Subject: Indian Point 3 Nuclear Power Plant
Docket No. 50-286
Additional Information Related to NUREG-0737, Item II.D.1;
Pressurizer Safety and Relief Valves (PRZR. S/RVs) Testing

RESPONSE TO NRC 6/6/85 REQUEST
FOR ADDITIONAL INFORMATION
REGARDING
NUREG-0737, ITEM II.D.1
PERFORMANCE TESTING OF PRESSURIZER
SAFETY AND RELIEF VALVES

NEW YORK POWER AUTHORITY
INDIAN POINT 3 NUCLEAR POWER PLANT
DOCKET NO. 50-286

Fig. 6 DRAIN TANK

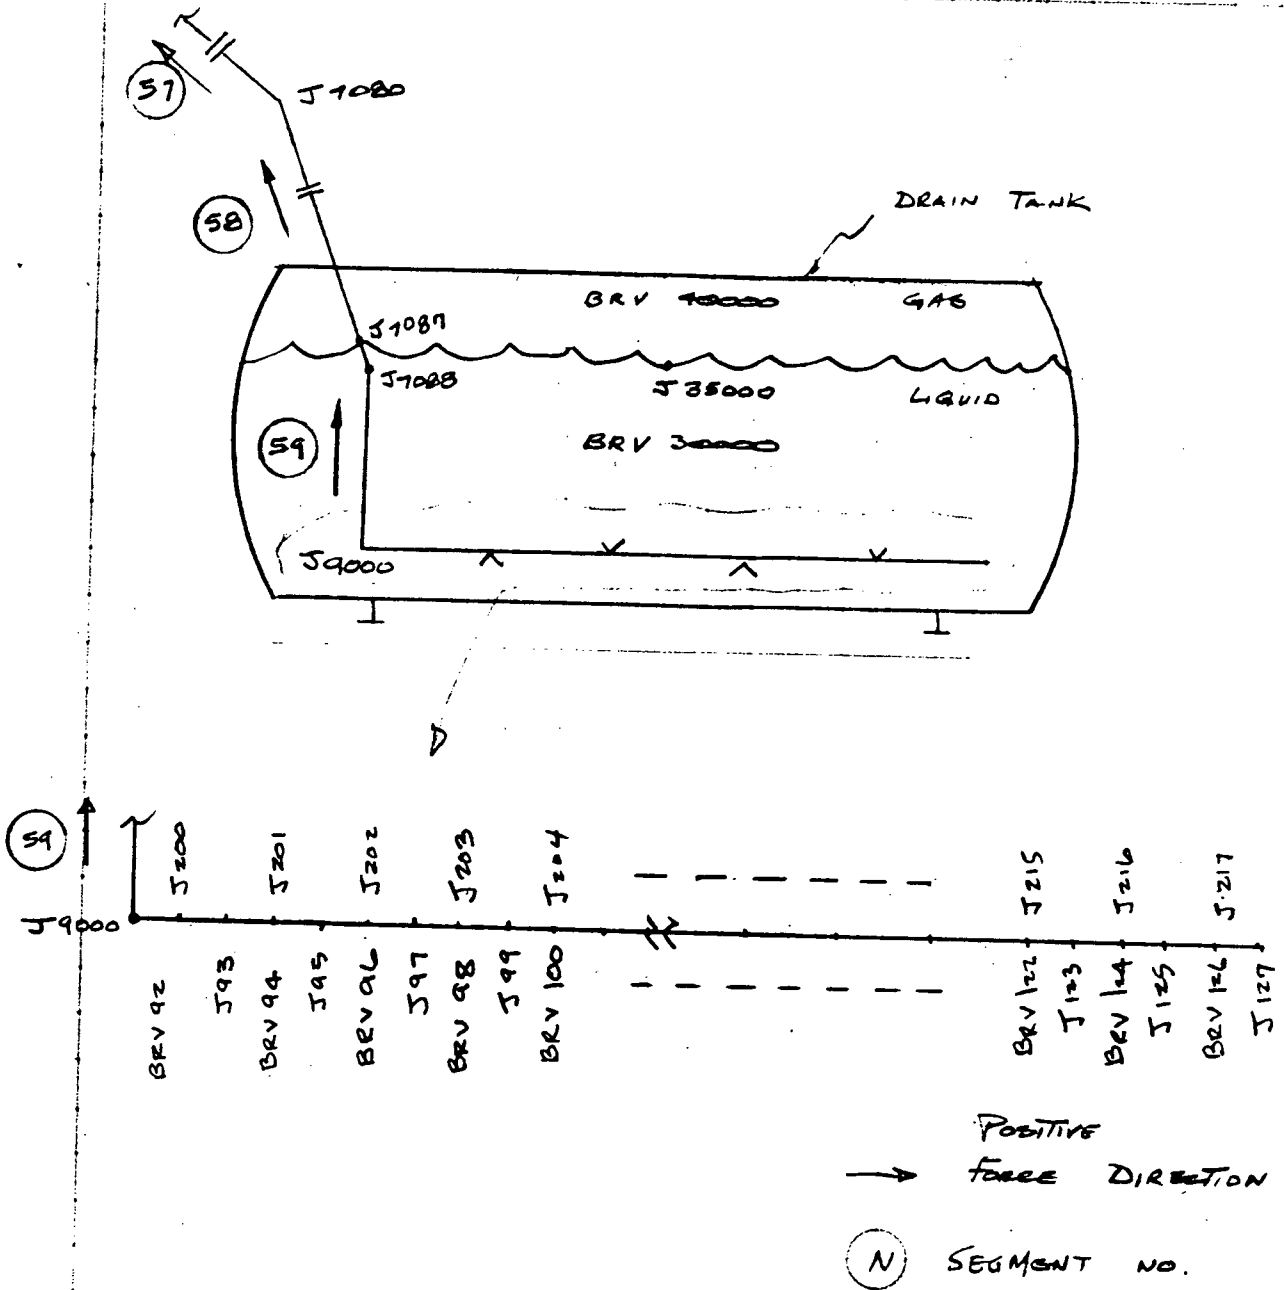
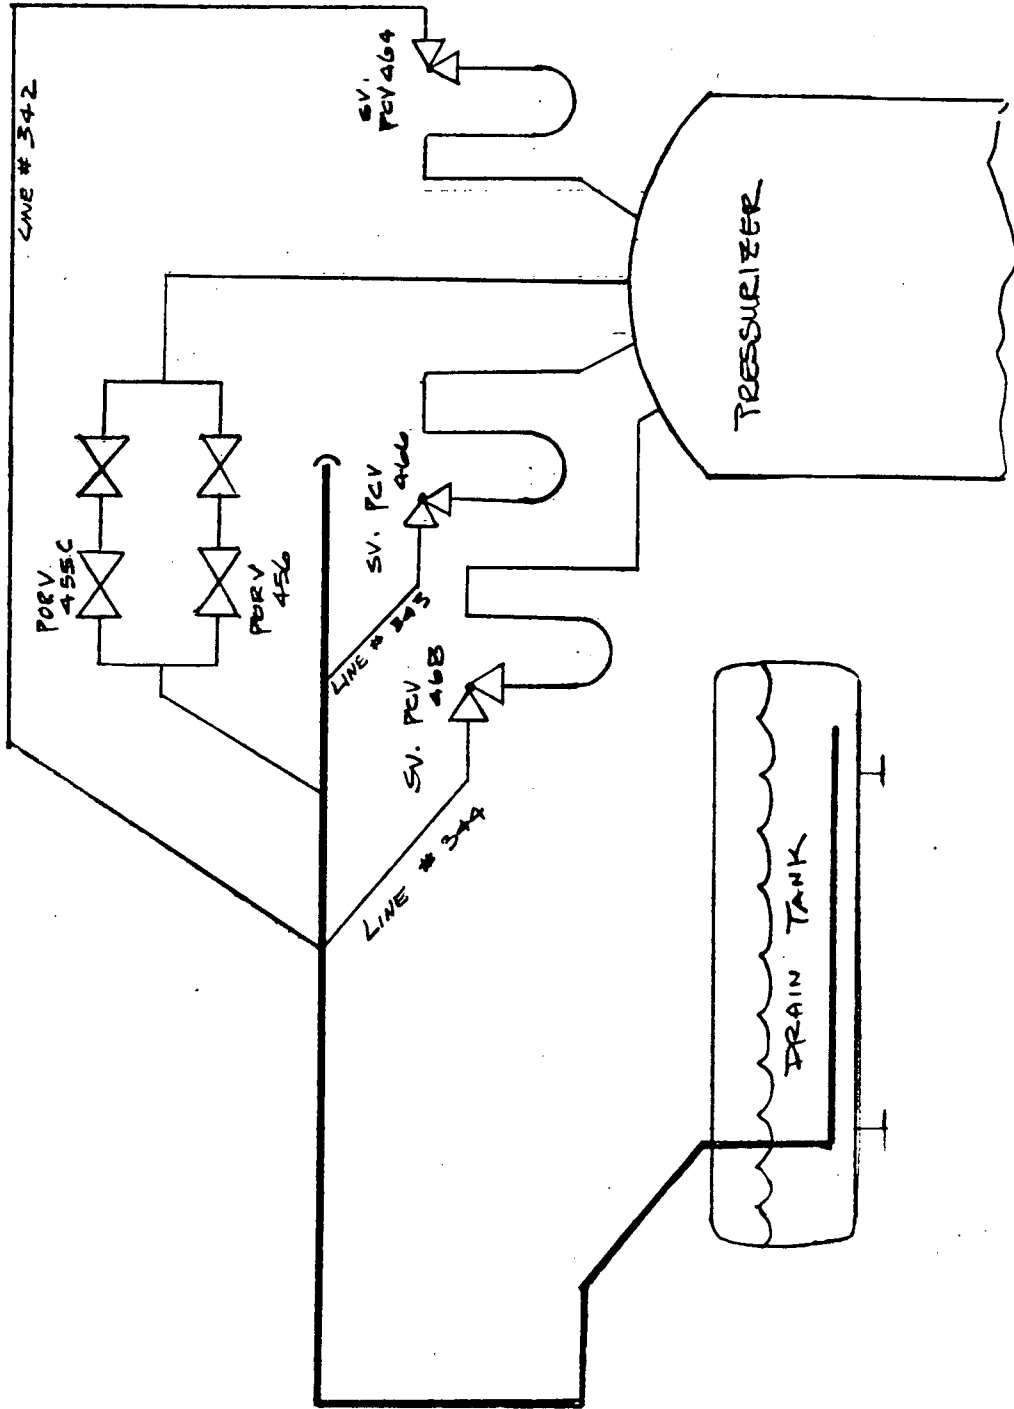
- (e) A discussion of the sequence of opening of the safety valves that was used to produce worst case loading conditions.
- (f) A sketch of the thermal hydraulic model showing the size and number of fluid control volumes.
- (g) A copy of the thermal analysis report.

11 (f) Isometrics of the thermal hydraulic model are shown in Figure 1 through 7 attached. The model consists of 292 volumes and 310 junctions. The average length of volume is less than one foot.

FIGURE 8(a)

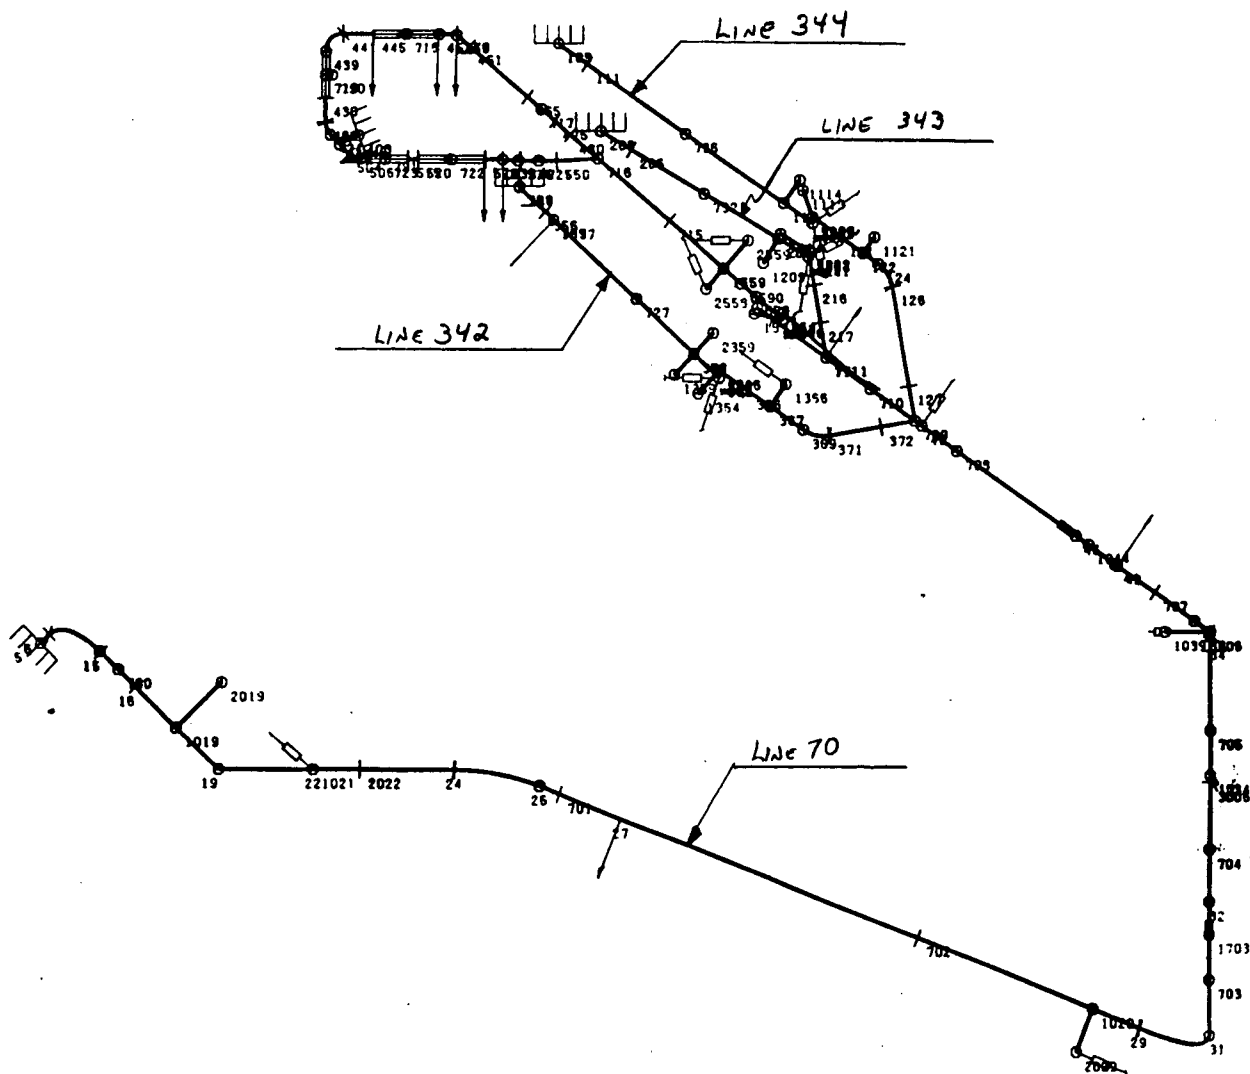
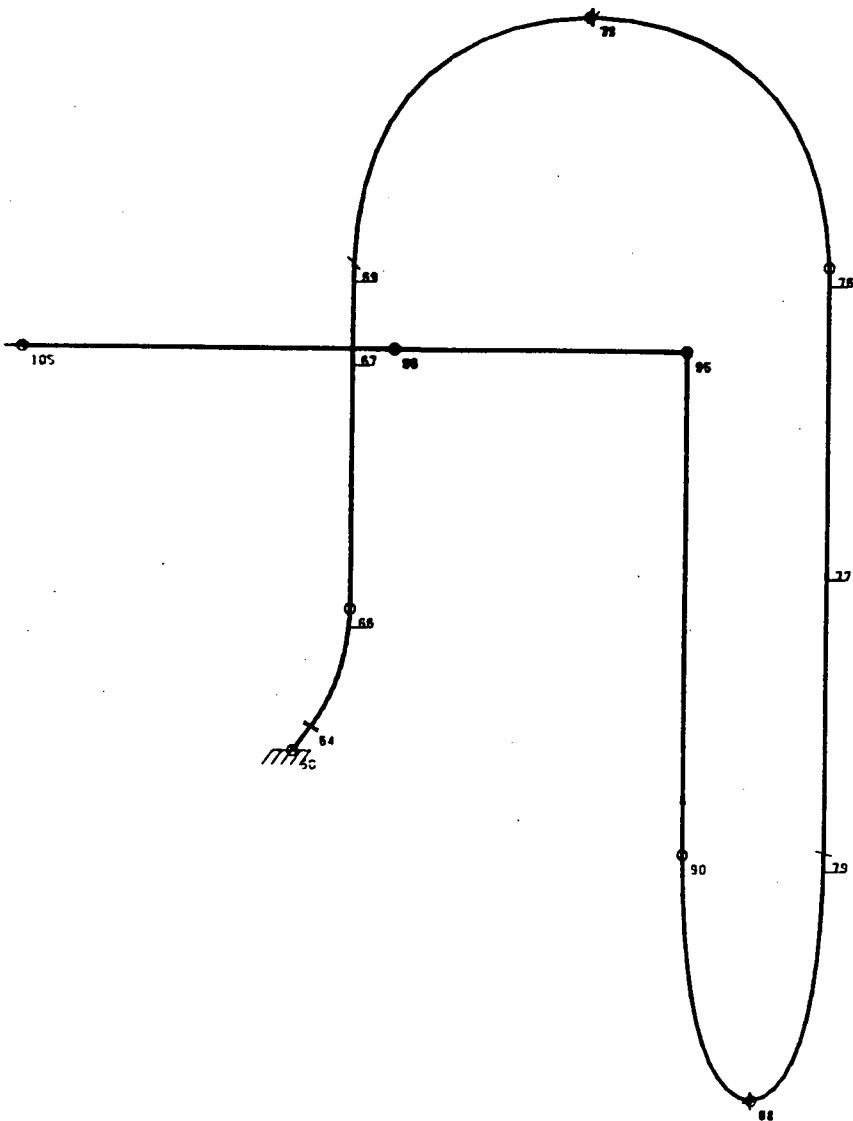
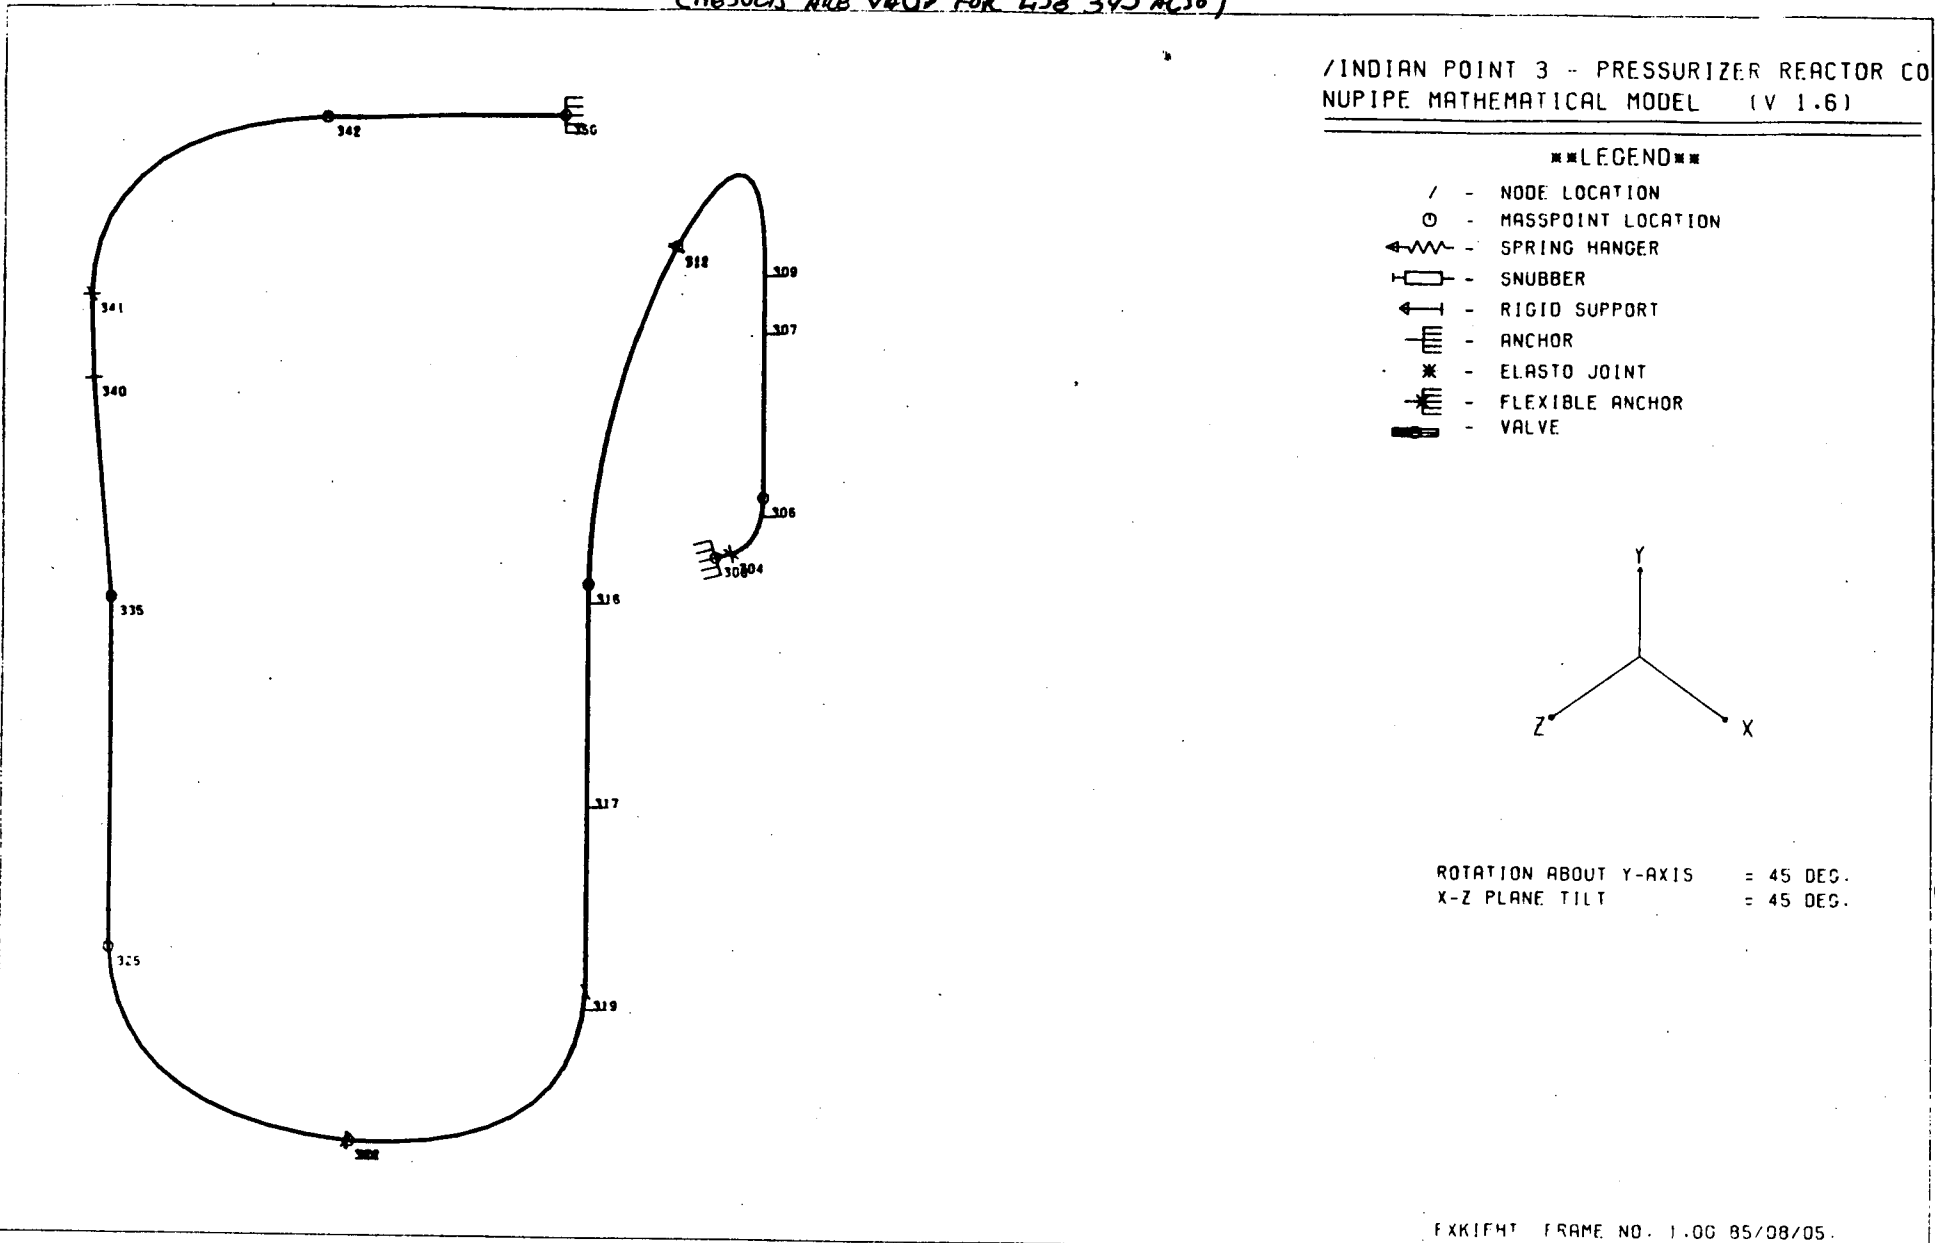
(f) A sketch of the structural model showing lumped mass locations, pipe sizes, and application points of fluid forces.

12 (f) A sketch of the structural model is shown in Figure 8.
